Subject: Workplan Addendum
3800 San Pablo Avenue, Emeryville, California
ACDEH Fuel Leak Case: RO00002520; Global ID: T06019788682

Subject: Workplan Addendum
3800 San Pablo Avenue, Emeryville, California
ACDEH Fuel Leak Case: RO00002520; Global ID: T06019788682

Subject: Partial Work Plan Approval and Request for Work Plan Addendum; Fuel Leak Case No. RO00002520 (Global ID #T06019788682), Maz Glass; 3800 San Pablo Avenue, Emeryville, CA 94608

INITIAL SITE CONCEPTUAL MODEL
Maz Glass UST Site
3800 San Pablo Avenue
Emeryville, California

DESIGNED BY:	CHECKED BY: JG	GROUNDWATER ELEVATIONS & HYDROCARBON RESULTS - 03/07/2014	DATE: 04/01/2014	FIGURE: 9
DRAWN BY: MR	SCALE:		GRIBI	
PROJECT NO:				
		3800 SAN PABLO AVENUE EMERYVILLE, CALIFORNIA

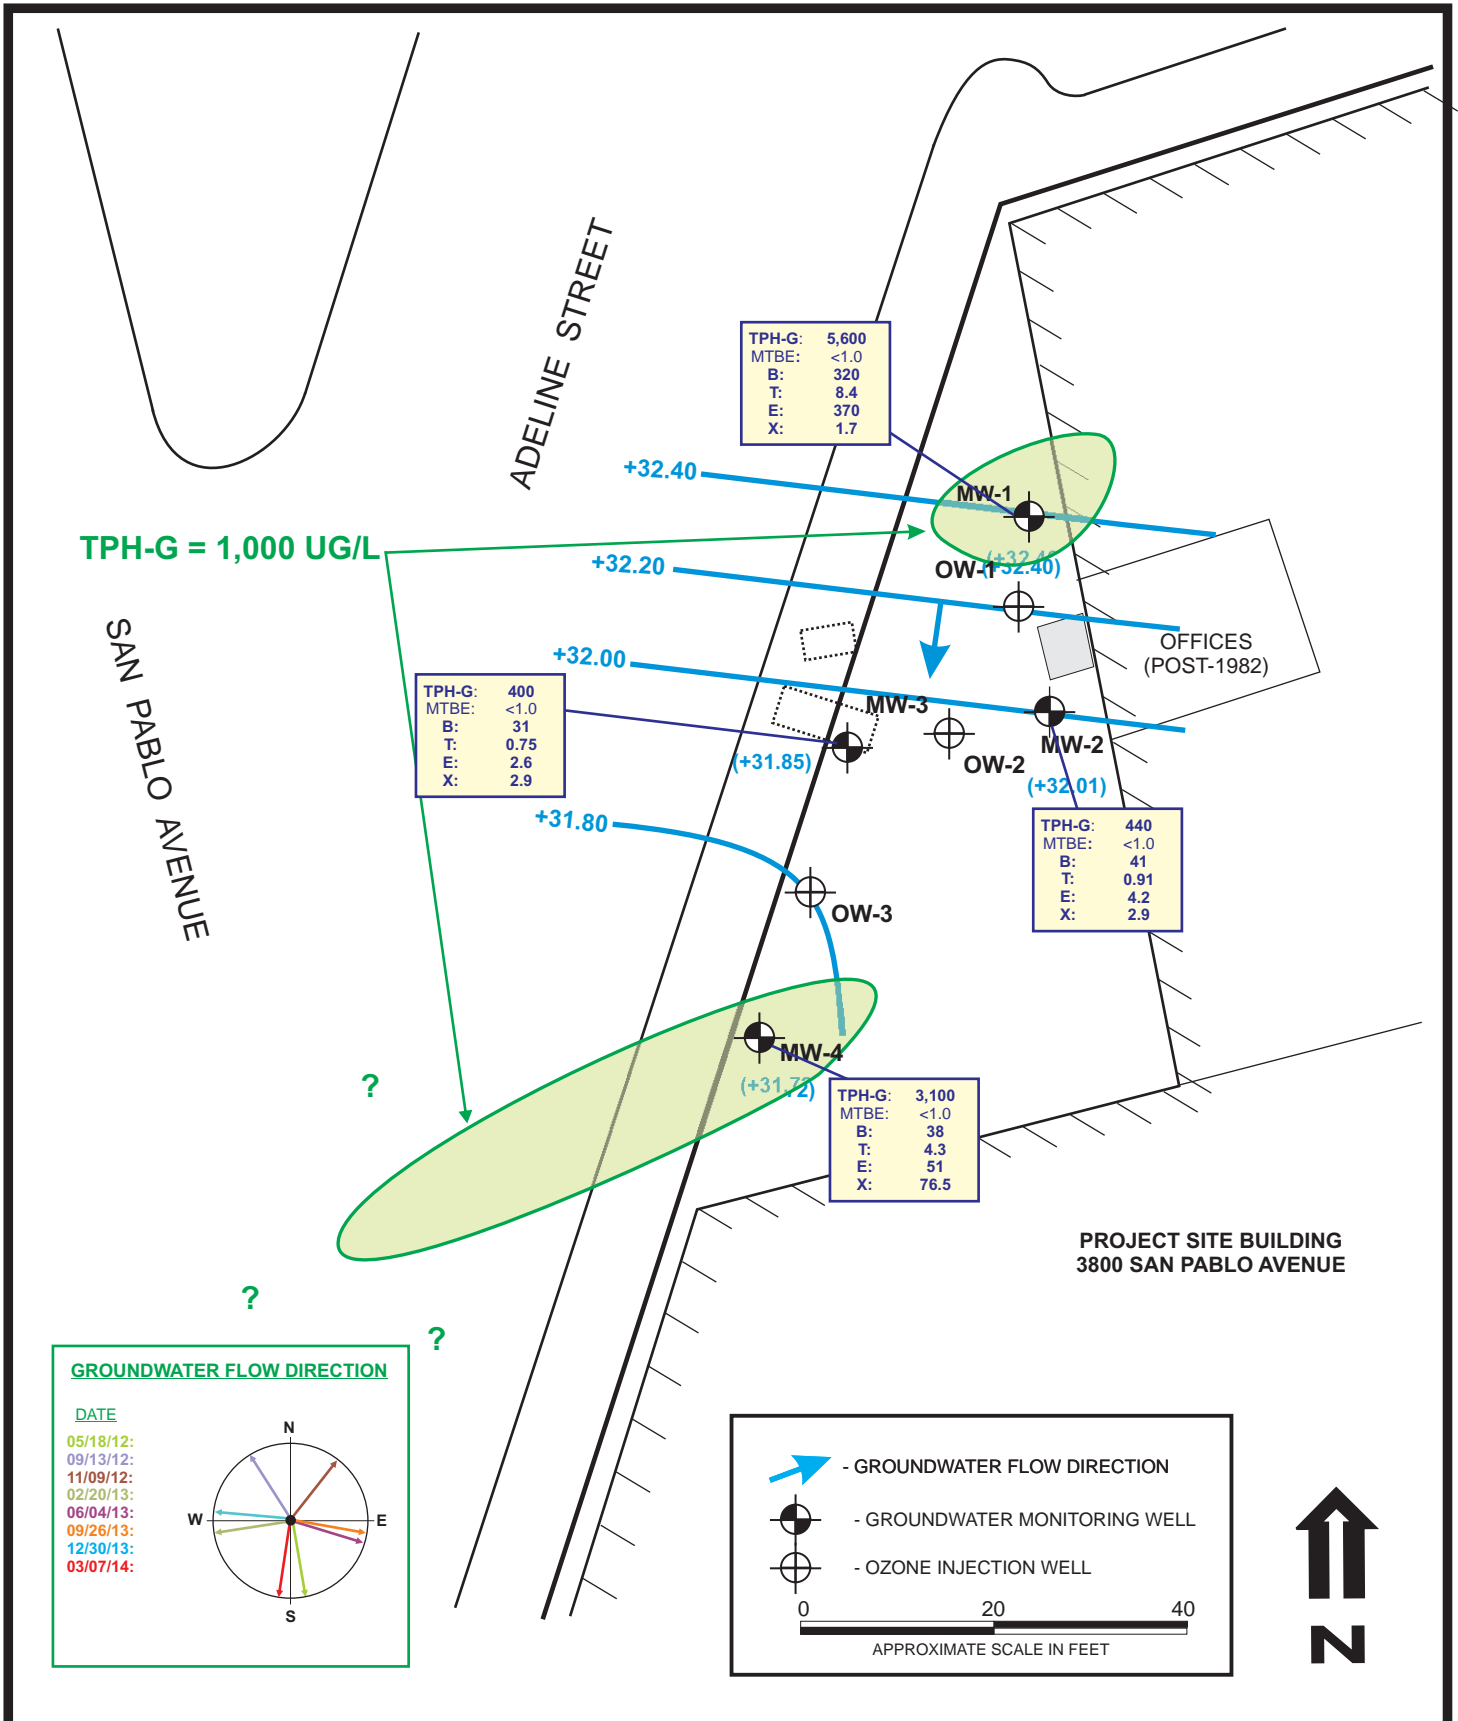
- **Additional Boring Locations** - The January 23, 2014 directive letter requested an assessment of the direction of groundwater flow as multiple flow directions have been documented by relatively few groundwater monitoring events at the site. As discussed in the meetings, the documented flow directions do not correlate with the apparent groundwater plume location. The use of a rose diagram to document groundwater flow directions was requested with a discussion of causes of groundwater direction changes.

Please evaluate groundwater flow direction and existing data as discussed above, and provide a revised figure (as a Work Plan Addendum) showing the locations of additional proposed borings to address these data gaps and support the locations with a rose diagram of groundwater flow directions.

- **Additional Boring Locations** – A rose diagram was presented at the April 18 meeting and was included in the SCM as Figure 9. During the April 18 meeting, we discussed our conclusion that, while the groundwater potentiometric gradient fluctuates (probably due to both vertical and lateral confining pressures), the well-defined delineation of the groundwater hydrocarbon plume clearly identifies a southwesterly groundwater flow direction from the known source area.

**LABORATORY CHROMATOGRAMS FOR
BORING B-28 SOIL AND WATER SAMPLES**

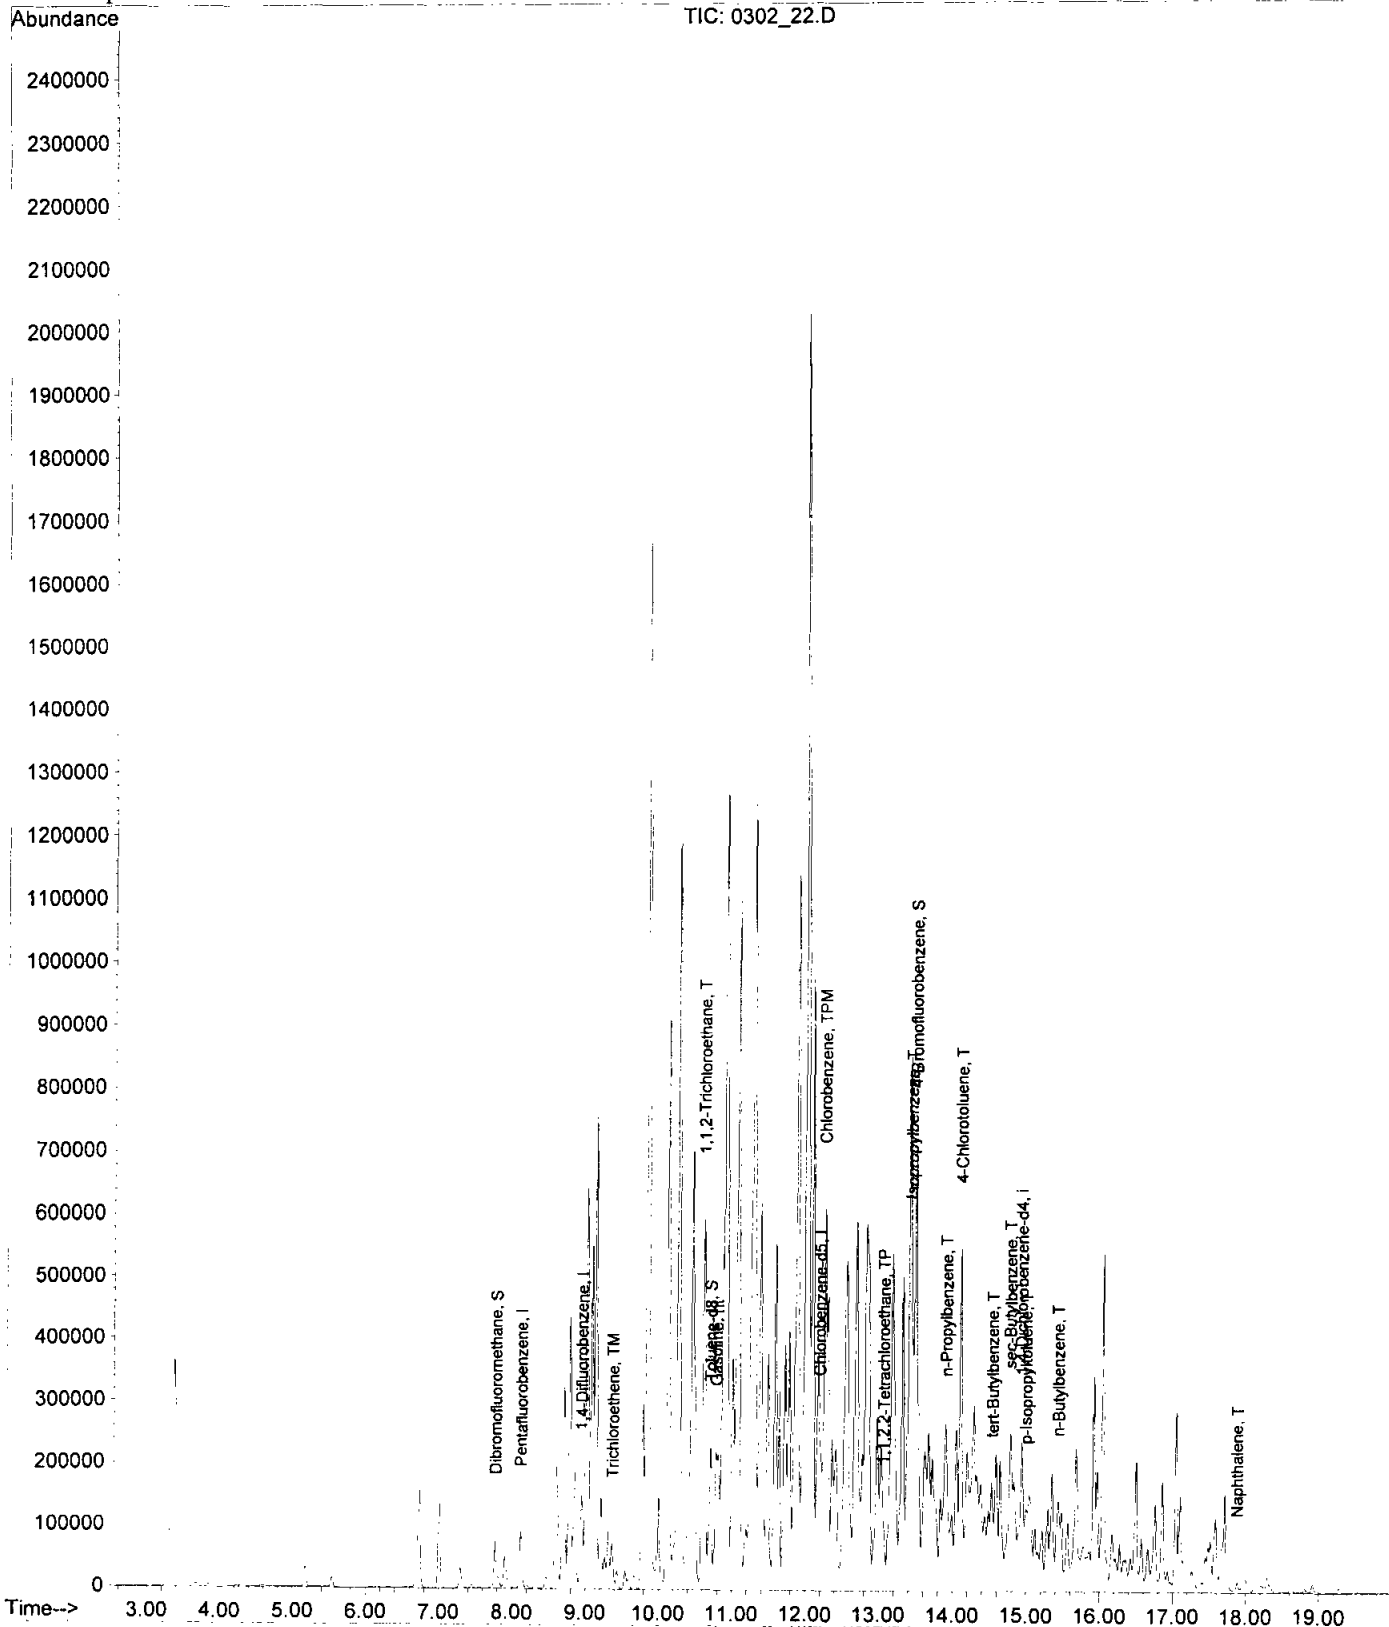
- d. **Submittal of Chromatograms** - ACEH also requested the submittal in the SCM of chromatograms of the TPHg analysis for soil and groundwater collected at soil bore SB-28 in an effort to determine the presence and magnitude of diesel or heating oil compounds this location. As ACEH has previously noted, soil analytical data from soil bore B-28, installed adjacent to a former heating oil UST near the intersection of Apgar Street and San Pablo Avenue, was analyzed for Total Petroleum Hydrocarbons as gasoline (TPHg). The groundwater analytical data detected 910 micrograms per liter (ug/l) TPHg, a concentration that can imply much higher diesel or heating oil concentrations, and indicates that plume delineation in this area of the site has not been achieved.

- d. **Submittal of Chromatograms** – The requested soil and water sample chromatograms from boring B-28 are included in Attachment C. These chromatograms indicate only gasoline-range hydrocarbons in the soil and groundwater samples from B-28. Note that the Apgar Street sidewalk UST was not identified as a heating oil tank, but rather of unknown origin and use. Also, a full suite of laboratory analysis of soil samples from the tank removal showed only 0.52 mg/kg of TPHg, with no detectable concentrations of diesel- or motor oil-range hydrocarbons.
